RBG-47895

SUBJECT: Supplement to the Response to License Amendment Request (LAR) for Review and Approval Of Relocation Of The Reactor Core Isolation Cooling (RCIC) Injection Point NRC Request for Additional Information (RAI)
River Bend Station, Unit 1
Docket No. 50-458
License No. NPF-47

Supplement to the Request for Additional Information (ML18172A142)
RIVER BEND STATION, UNIT 1
DOCKET NO.: 50-458

Thermal Transient Loss of Feed Water Pumps Aux Power Trip without Bypass and
Reactor Core Isolation Cooling (RCIC) Injection AX-17D Rev 3K

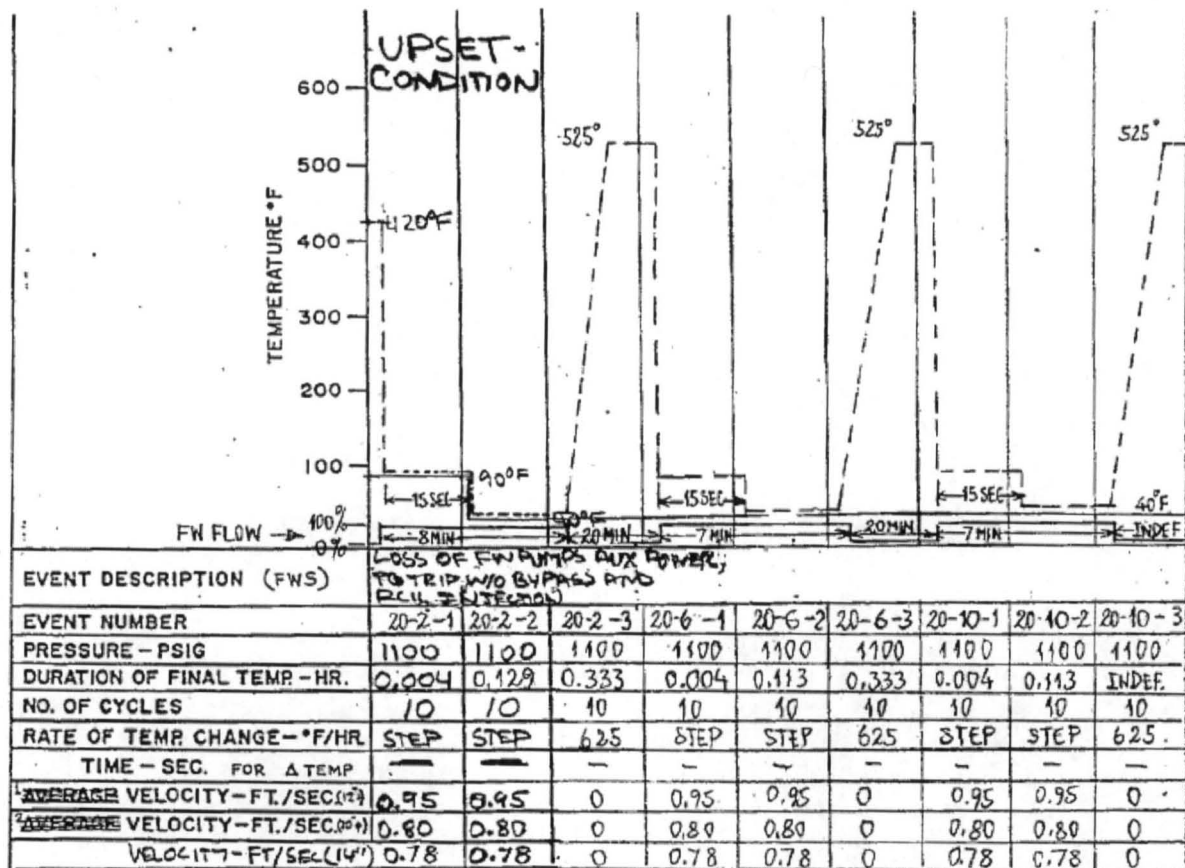
3K incorporated the changes made by addenda 3B, 3E, 3F, 3G, 3H, and 3J. Addendum 3K evaluated the Feedwater piping for the new function of RCIC injection in addition to the existing Feedwater functions. Attachment 4 contains the cover page to AX-017D Addendum 3K for reference. The added check valve FWS-V3052 was added to the model and new thermal mode 36 was introduced for the injection of 40 deg F RCIC into the feedwater piping. This new thermal transient includes 10 postulated events with 3 injections per event (total of 30 cycles) with no feedwater flowing. In addition to these 10 injection sequences, there are 40 postulated spurious injections with feedwater flowing. The spurious injection of RCIC with feedwater flowing events were excluded from the analysis as the contribution to stress is minimal due to the low change in feedwater temperature. The thermal transient diagram for the new thermal transient is shown in Attachment 2.

The load cases and thermal modes from Revision 3 of AX-017D are located in Attachment 1. A new thermal transient was added with addendum 3K, the transient curve can be found in Attachment 2.
